Title: Advisory Committee on Reactor Safeguards  
Combined Thermal-Hydraulic Phenomena/  
Future Plant Design Subcommittee Meeting  
OPEN SESSION

Date: Friday, February 15, 2002

UNITED STATES OF AMERICA  
NUCLEAR REGULATORY COMMISSION  
+ + + + +  
ADVISORY COMMITTEE ON REACTOR SAFEGUARDS  
(ACRS)  
COMBINED THERMAL-HYDRAULIC PHENOMENA/  
FUTURE PLANT DESIGN: SUBCOMMITTEE MEETING

## 3-D CFD Air Mixing Evaluation

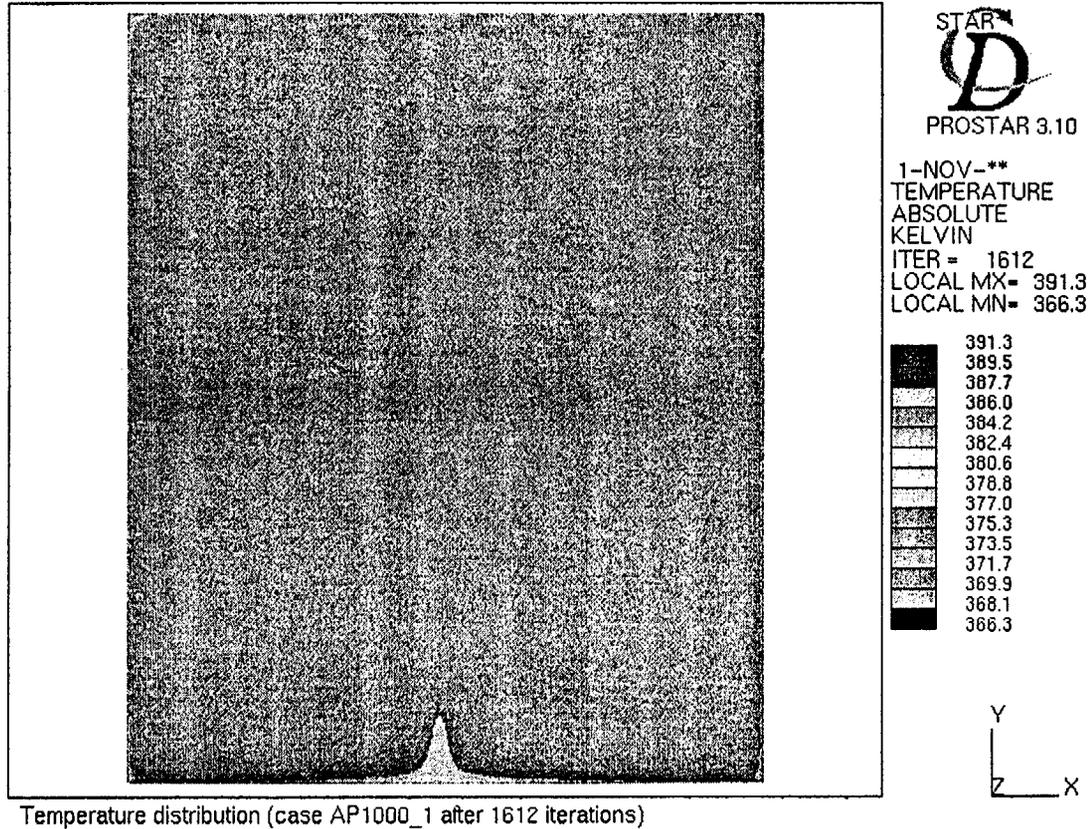
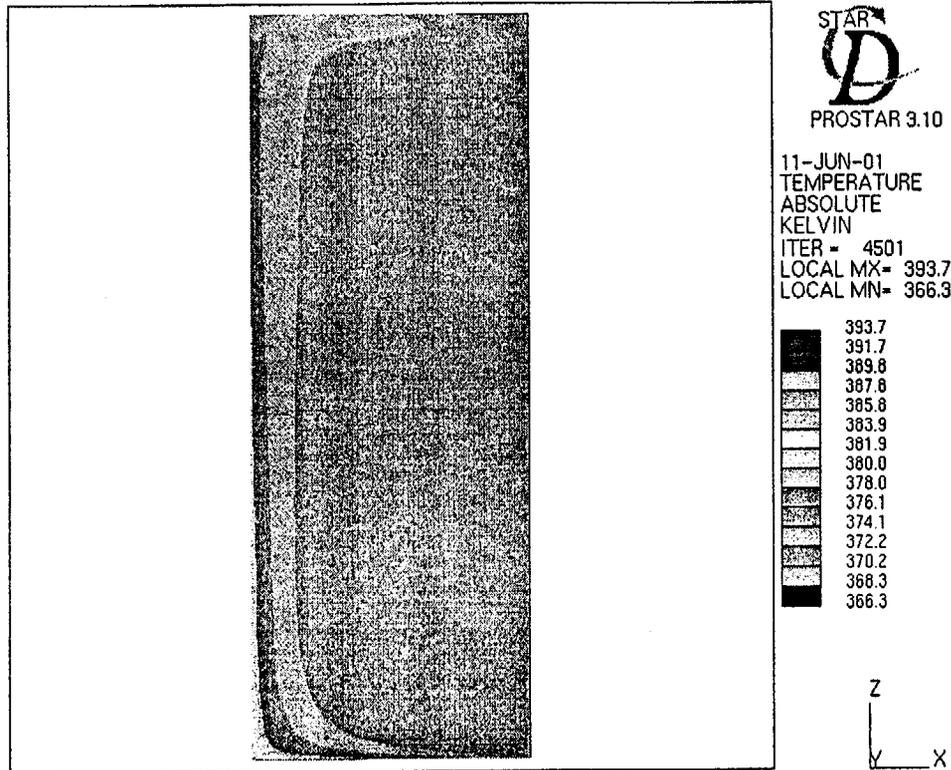
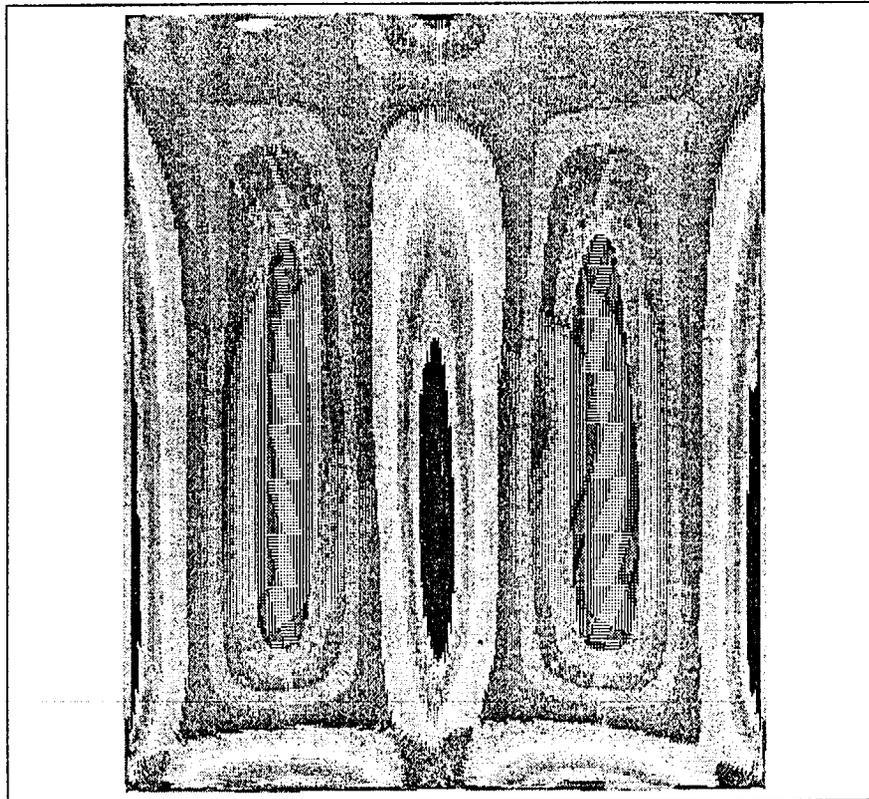
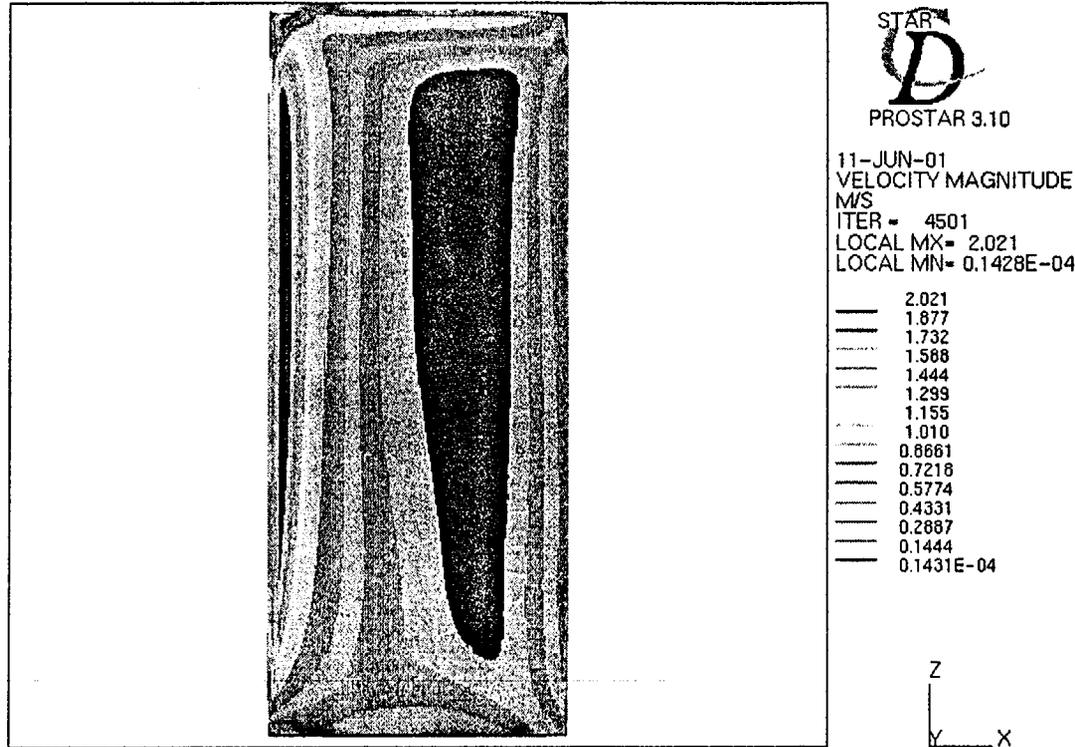
24 MEMBER WALLIS: So does this say it's well  
25 mixed or does it show that it is a sort of circulating

24 MEMBER WALLIS: I think we have to look at  
25 the change in temperature of that blue annular

18 MEMBER WALLIS: When you use k, it's  
19 difficult to see the differences. I guess what I  
20 would want to know is how much did that cold region,  
21 the one affected region, change its temperature. You  
22 can't tell just looking at it. That dark blue blob,  
23 that elongated donut thing -- it doesn't mix very  
24 much.

# AP600 vs. AP1000 2in49 Break Liquid Break Flow Rate

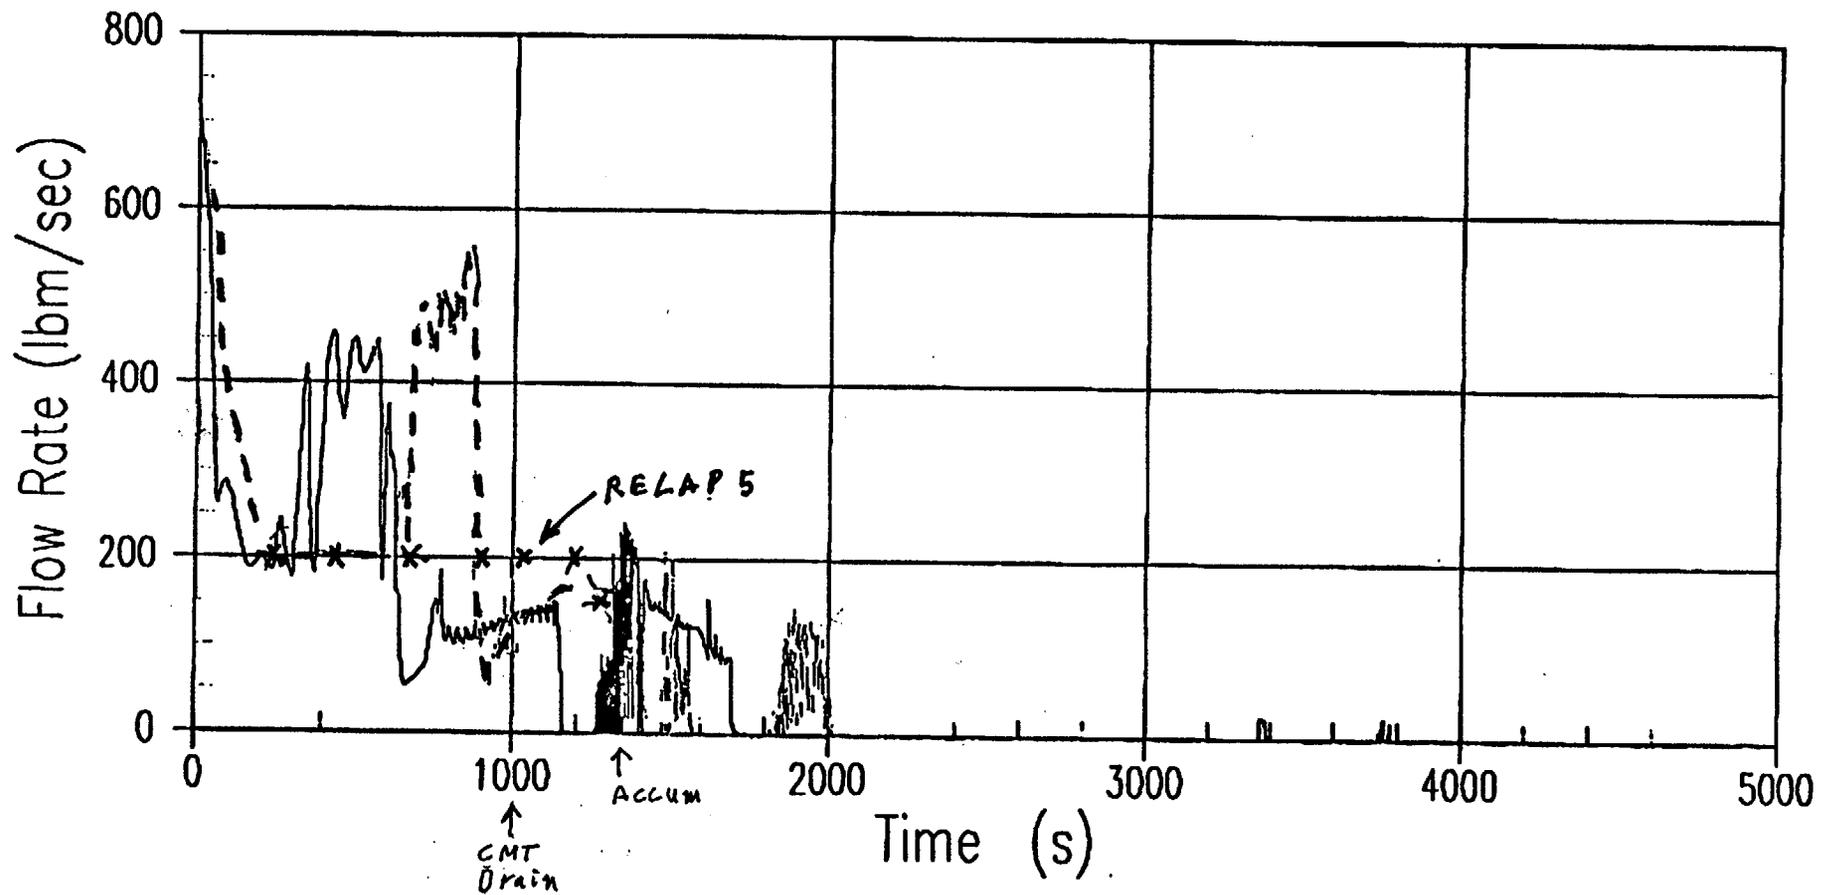
20 MEMBER WALLIS: If I look at these two  
21 curves, I'd say, well, AP600 and AP1000 don't have the  
22 same response, do they?

13                  MEMBER WALLIS: This is not very -- I  
14 think the real thing is that, if you scaled the break,  
15 you'll be able to show a much better comparison. That  
16 would be more meaningful than maybe trying to wring  
17 something out of this picture which is not very  
18 meaningful.

20 Really, what we saw was really a time  
21 shift for breaks of the same size. So that seemed to  
22 be consistent with -- That led us again to a judgment  
23 that the plants really do operate from a scale basis  
24 the same.

Figure 21.6-22. AP600 Containment

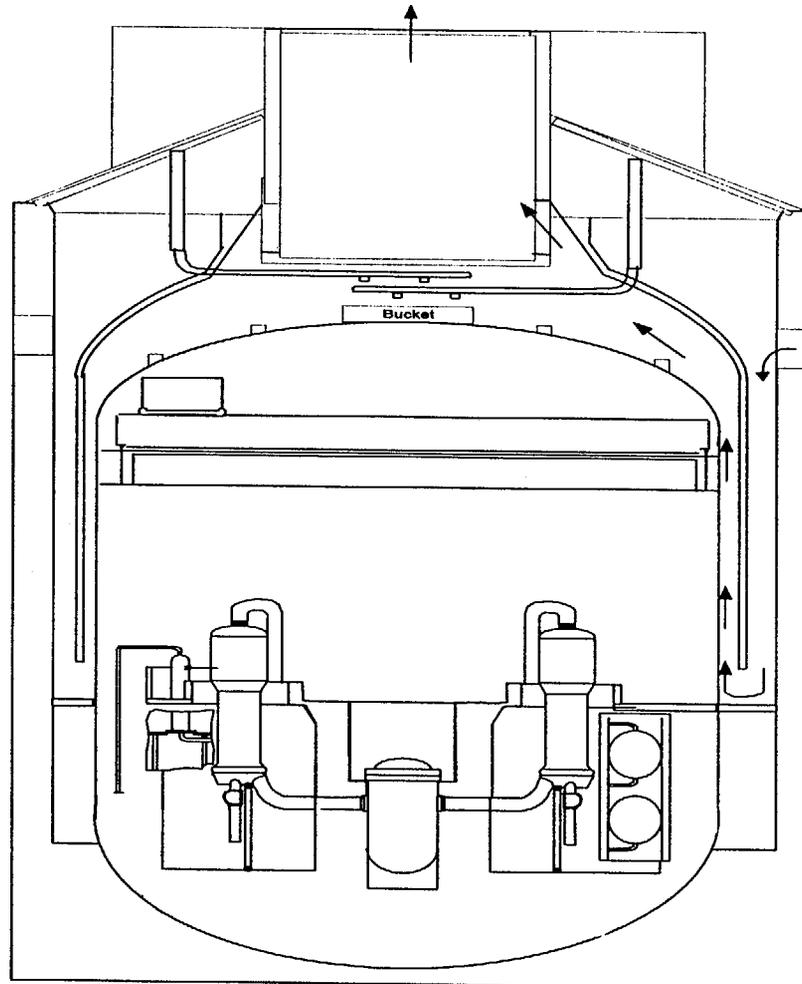
**Westinghouse should conservatively predict any decreased homogeneity using the lumped-parameter model.**

- The loss coefficient in the external annulus should include a 30 percent increase over the value derived from the test program.
- Condensation and convection on heat sinks in the dead-ended compartments, below the operating deck, should not be credited after the blowdown period. This conservative assumption should also be employed for MSLB analyses.
- Heat transfer to horizontal, upwards facing surfaces which may become covered with a condensation film is not credited. In particular, the operating deck itself, which becomes covered with an air rich layer, should not be credited.
